McLaren Artura - Air Feed Hose Retention Inspection

Bulletin type:	Service Campaign
Reference number:	N/A
Campaign reference:	SCB 16 E 001
Attention:	Retailer Aftersales Managers, Retailer Service Managers, Retailer Service Advisors, Retailer Technicians, Retailer Parts Managers
Affected vehicles:	McLaren Artura
Situation:	Air feed hose retention inspection for correct cable tie edge clip presence and position
Procedure:	Action affected vehicles during next Retailer visit. Please refer to the information outlined in this document to complete the required work
Date:	10 October 2023

Image 1 Location of the retaining clip. Image shows correct cable tie with an edge clip (1)

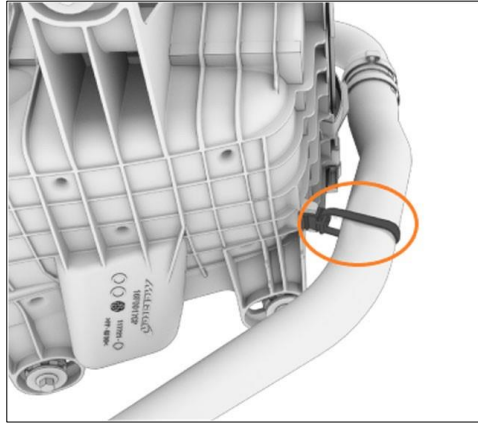
Through continuous product quality monitoring, it has been identified that the air feed hoses to the turbocharger wastegate(s) may be retained with an incorrect clip. McLaren Automotive has released the inspection and installation instructions outlined in this document to ensure correct retention clips are fitted to this air feed hose assembly.

Part Number	Part Description	Quantity Required
00RL022	EDGE-CLIP-TIE-WRAP 202X4.6MM INLINE	2 (one per engine bank)
